Addendum No. 2

Subject: W.B. Saul High School – New Livestock Center
SDP Contract Nos. B-011C, B-012C, B-013C of 2017/18

This Addendum, dated 25th of April, 2018, shall modify and become part of the Contract Documents for the work of this project. Any items not mentioned herein, or affected by, shall be performed strictly in accordance with the original documents.

A2.01

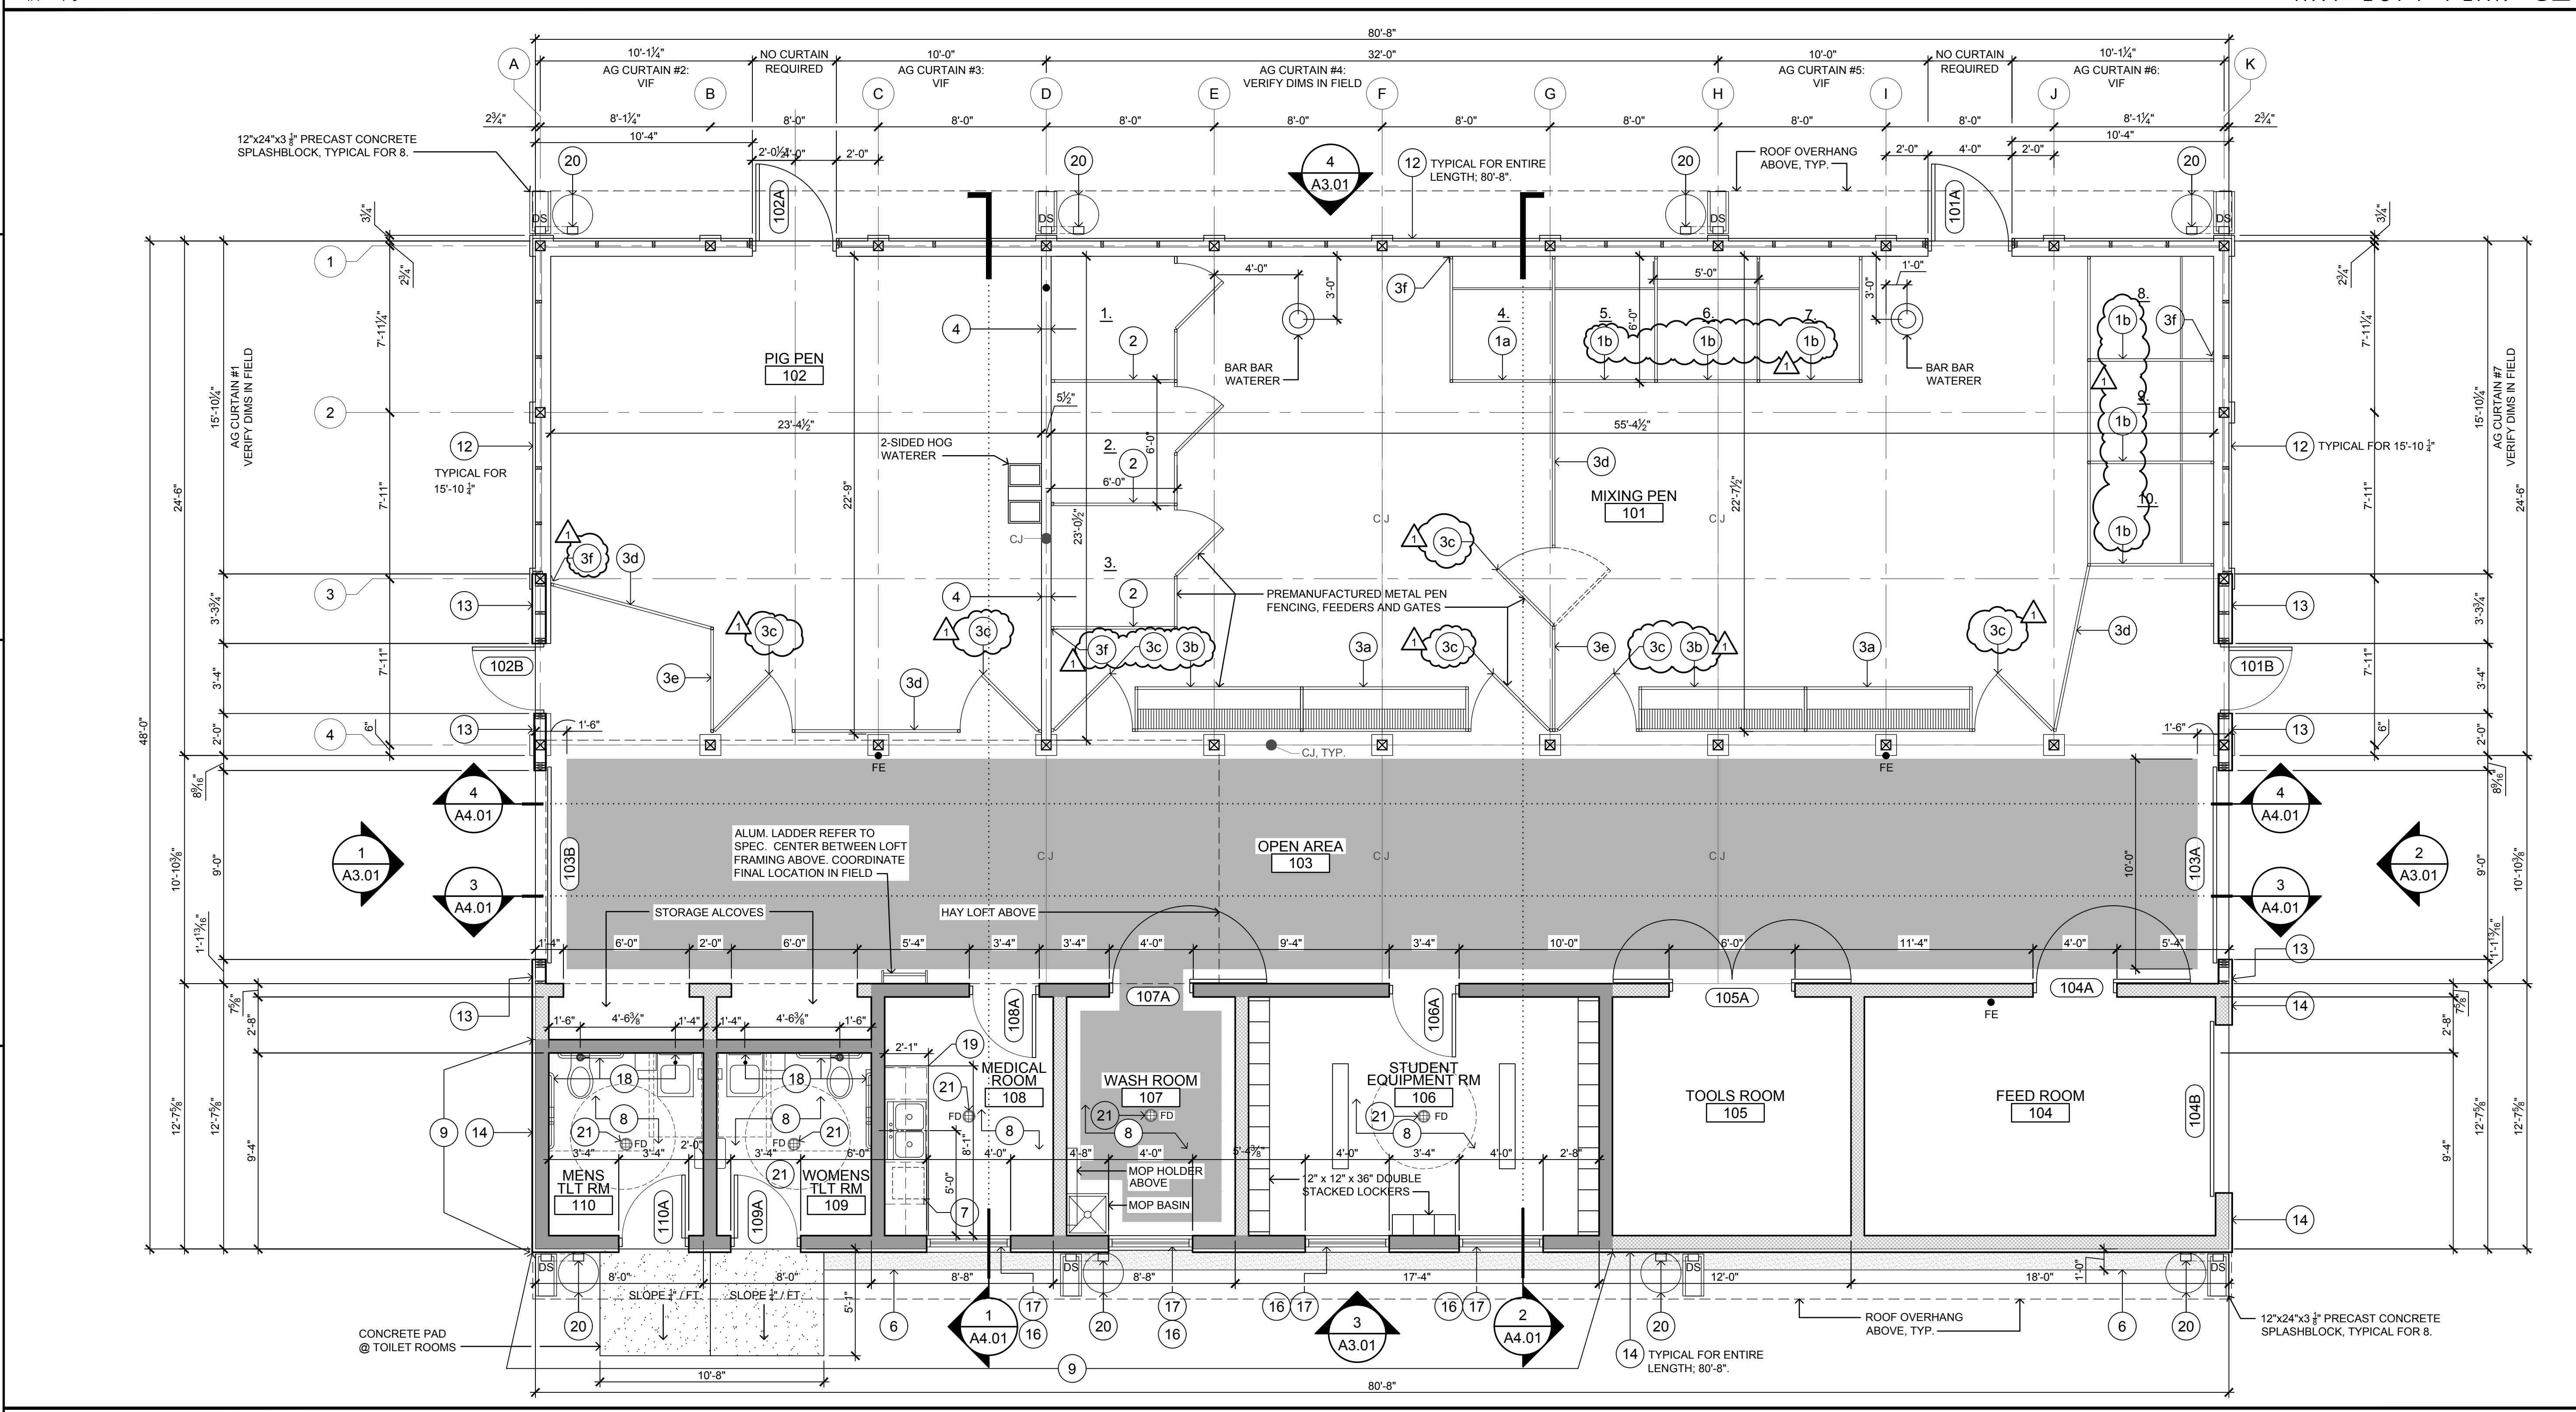
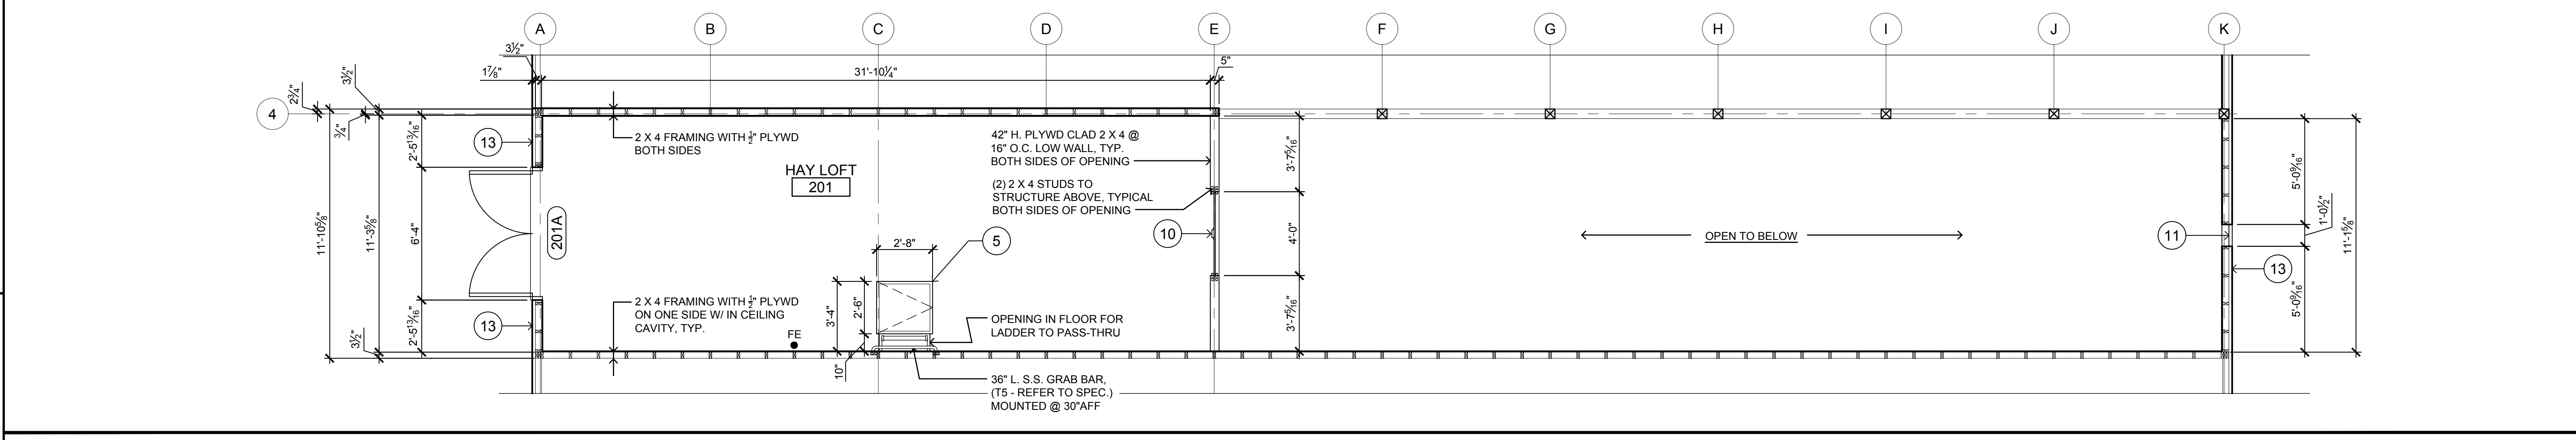
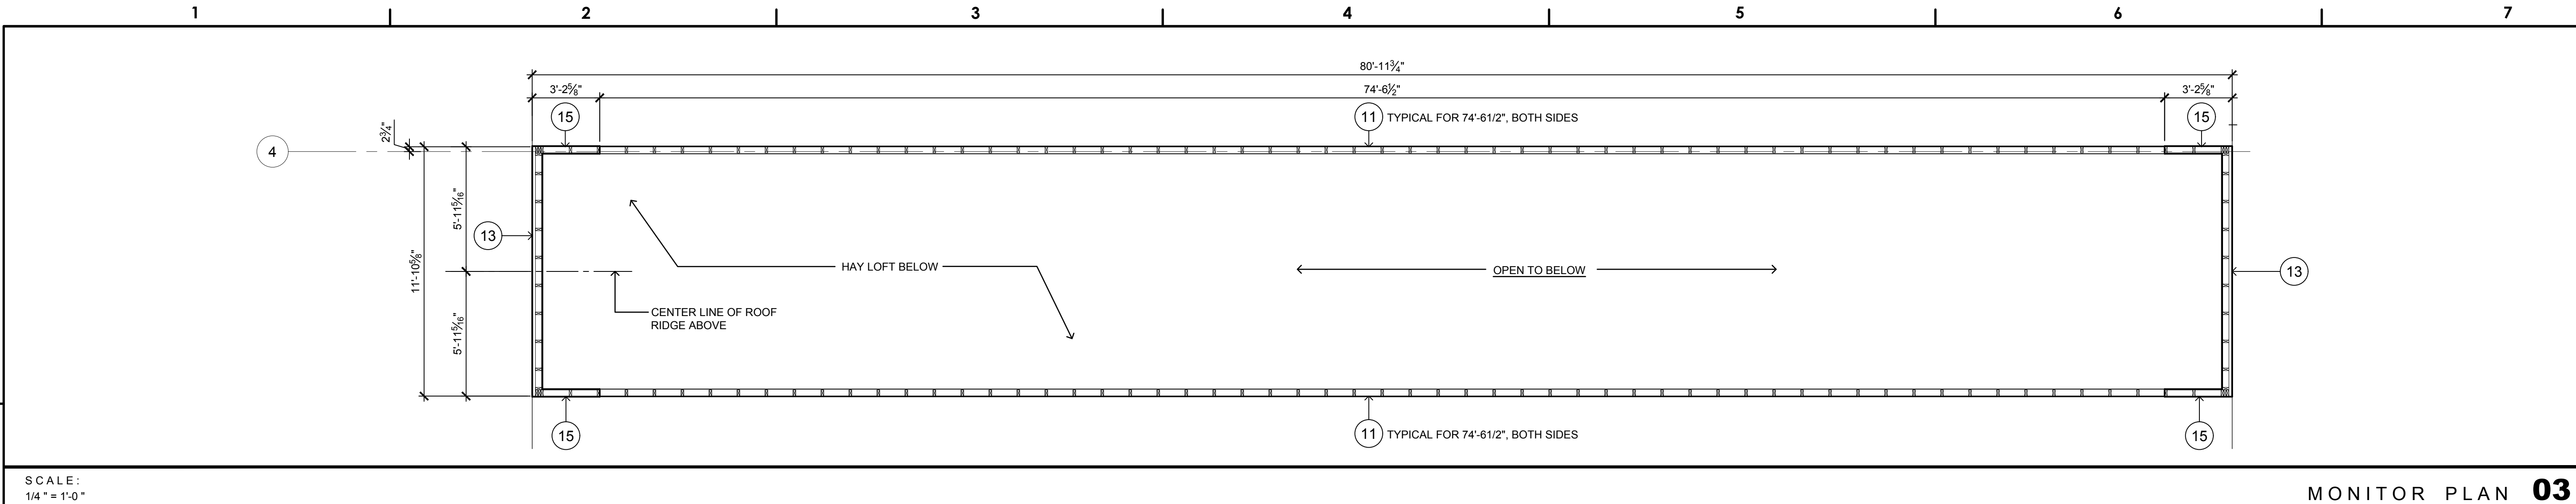
- a. Corrected plotting error for □ at Key Notes 1b, 3b, 3c and 3g.

STORAGE WATER HEATER PIPING 04

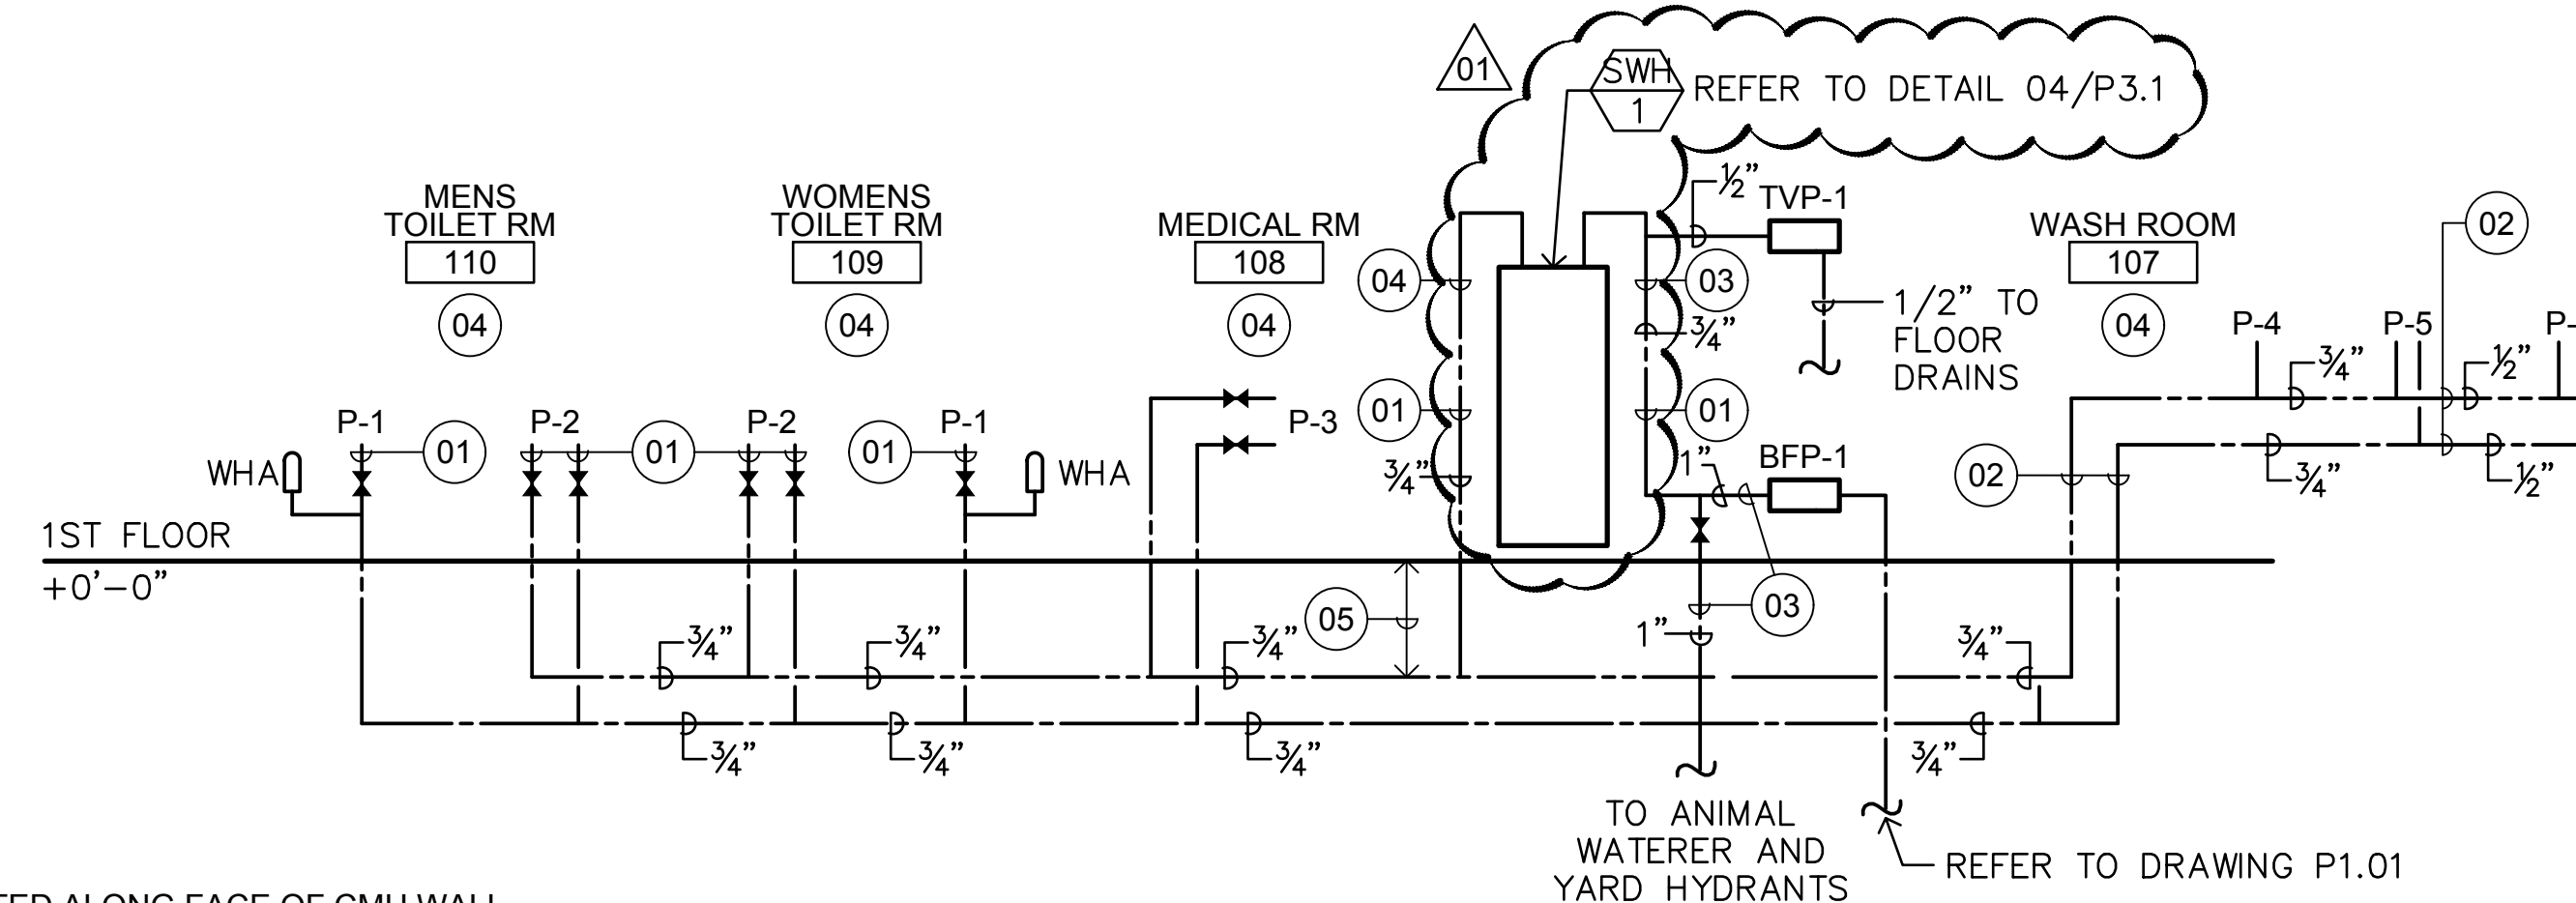
- a. Revised Detail 4 (hot water heater is revised from tankless water heater to storage tank water heater).
- b. Revised the Water Heater Schedule (hot water heater is revised from tankless water heater to storage tank water heater).
- c. At Detail 03 Water Riser Diagram, revised water heater to storage water heater (tank type).
